Solicitation Addendum

Addendum No.: 2
Solicitation No.: 18-TA002764JP
Project No.: 6086160
Solicitation Title: Rye Road Functional Improvements and Master Lift Station
Addendum Date: June 11, 2018
Procurement Contact: Joe Pretorius, johannes.pretorius@mymanatee.org

STRUCTURAL REHABILITATION EYE ROAD BRIDGES @ MULL CREEK BRIDGES #134025 & #134026

RYE ROAD BRIDGES
OVER MILL CREEK
STRUCTURAL REHABILITATION

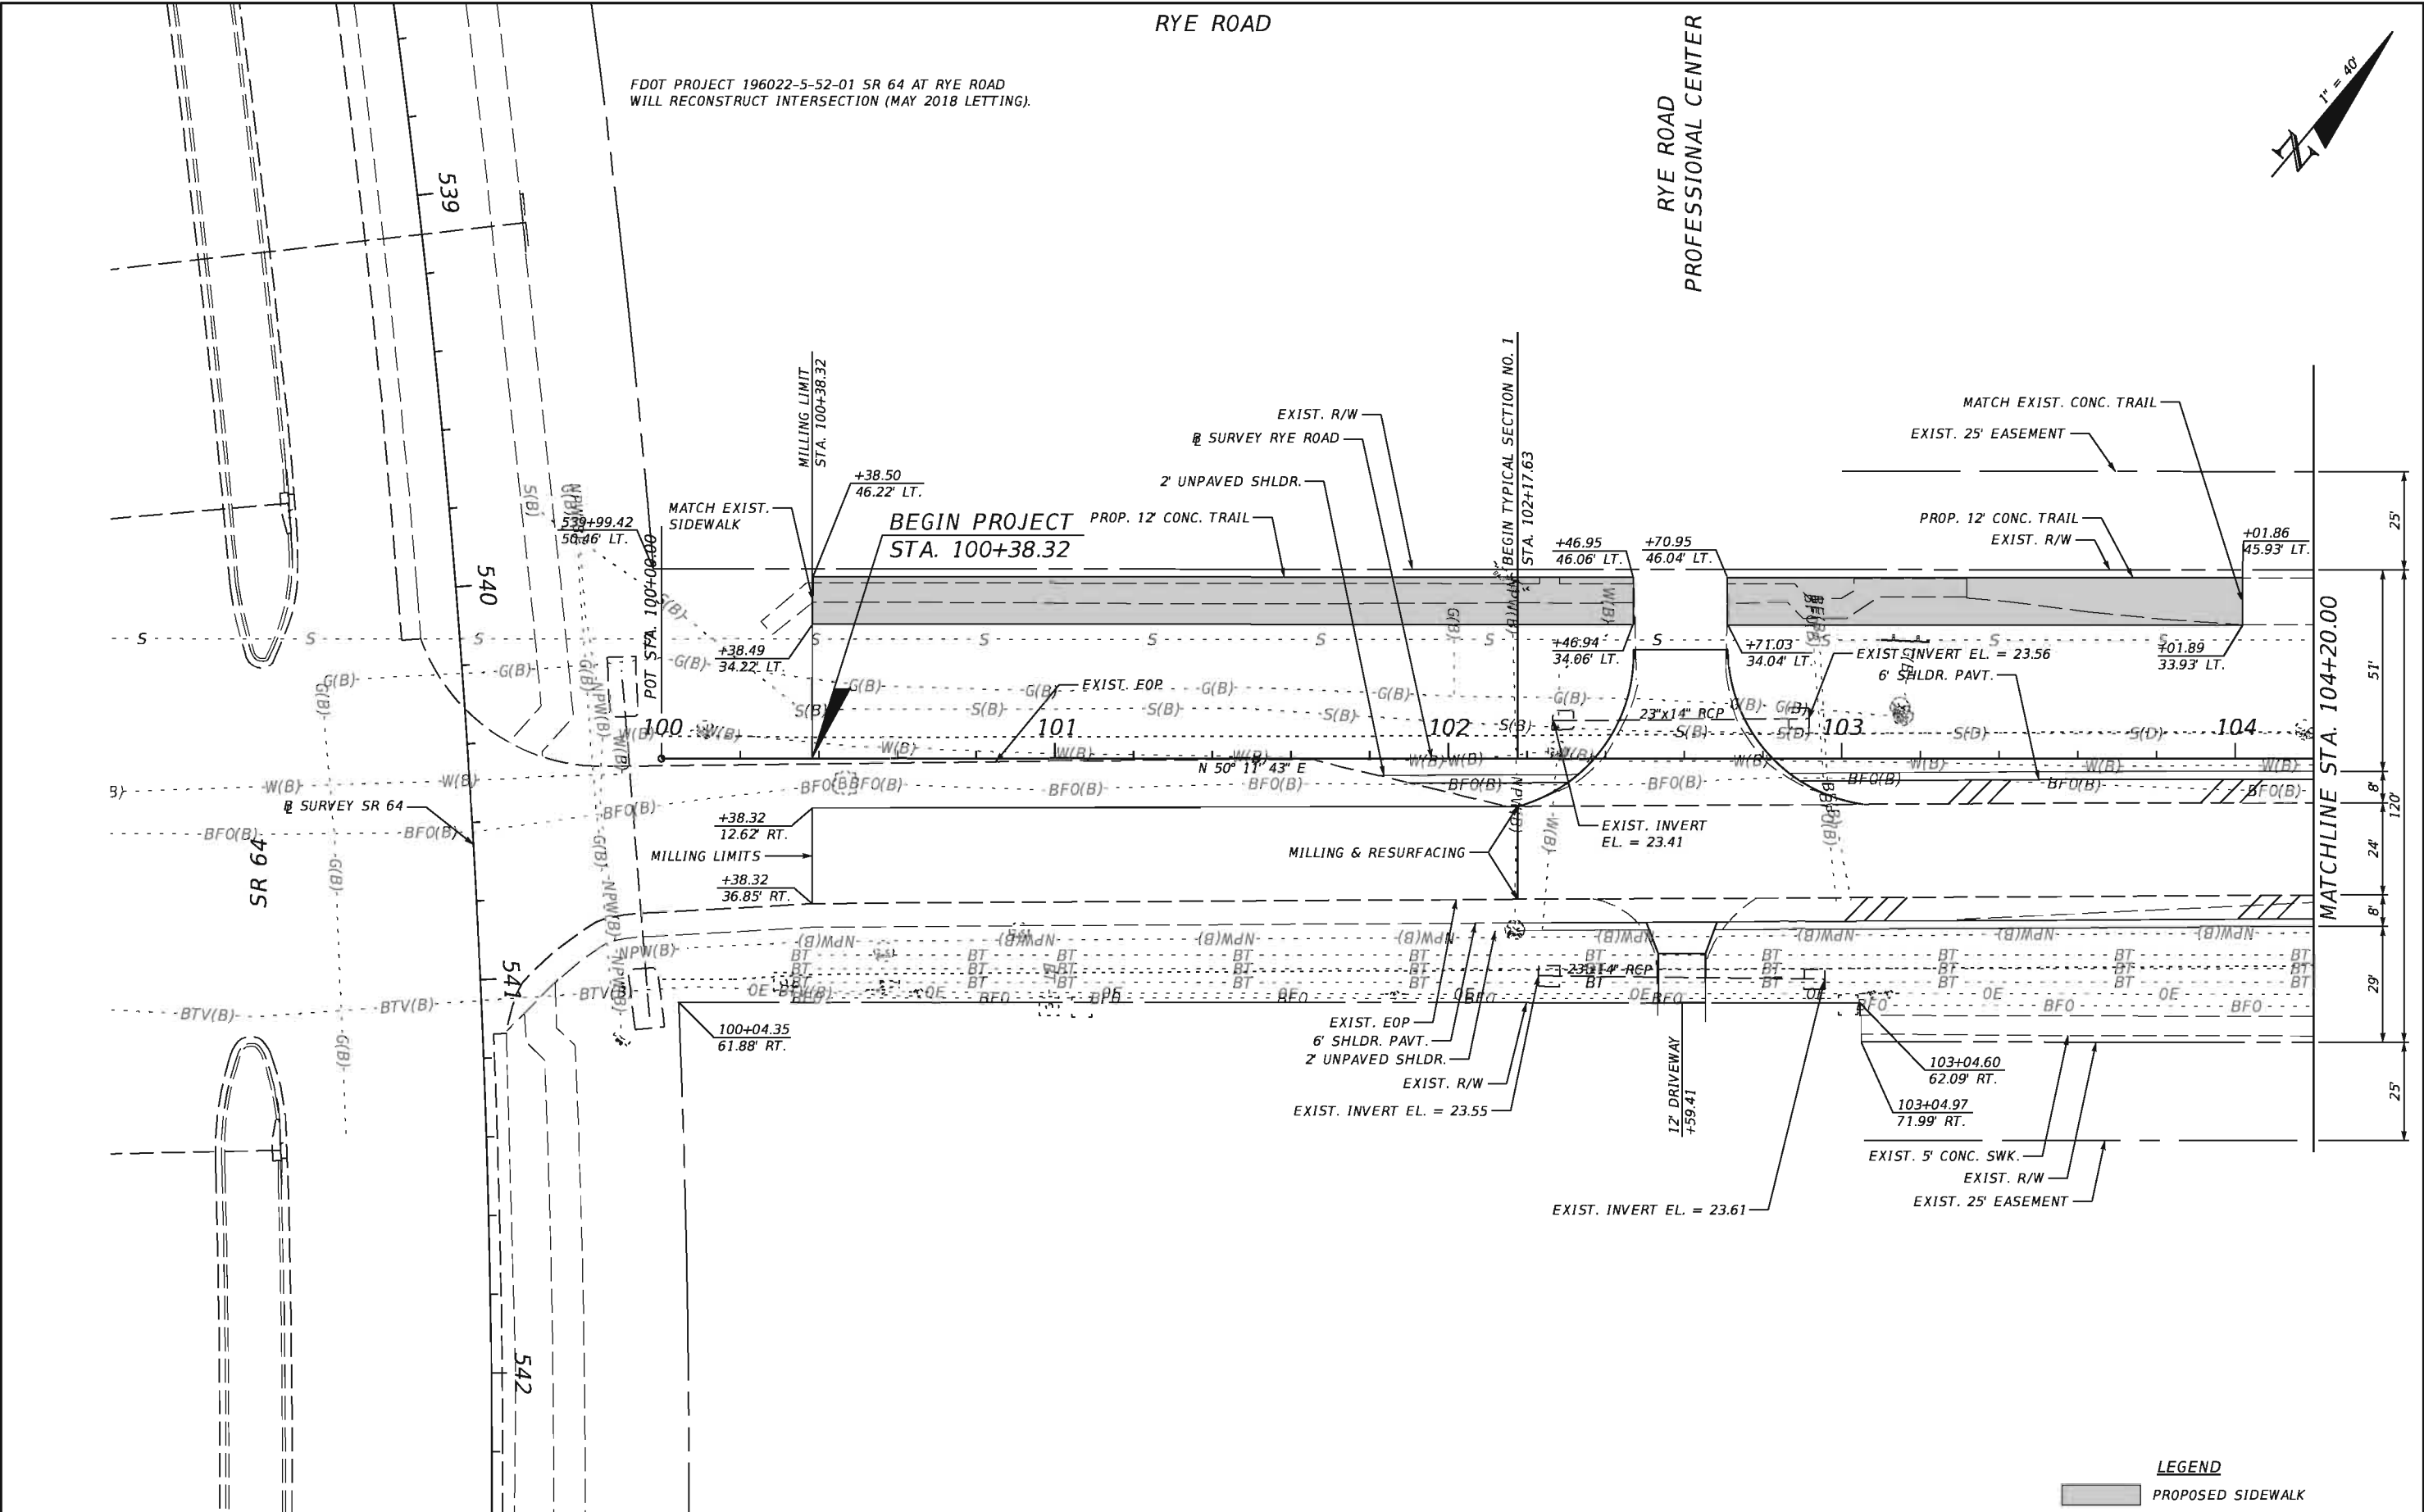
3. Sheet No. 9 - Roadway Plan (1) – Existing pipe sizes added [Question 18]
4. Sheet No. 10 - Roadway Plan (2) – Existing pipe sizes added [Question 18]

Q18. Referencing the General Notes, note #10 states, "All existing drainage structures, underdrain systems, ditches and ponds are to remain unless otherwise noted". There are no call outs for any of the existing drainage pipe to be removed where it appears that the pipe should be removed. How do we determine what is to be removed and what is not? Please clarify.

R18. Where new sidewalk construction / excavation impacts existing drainage pipes, the intent is to remove the existing pipes. Removal callout notes have been added to the plans per this Addendum No. 2.
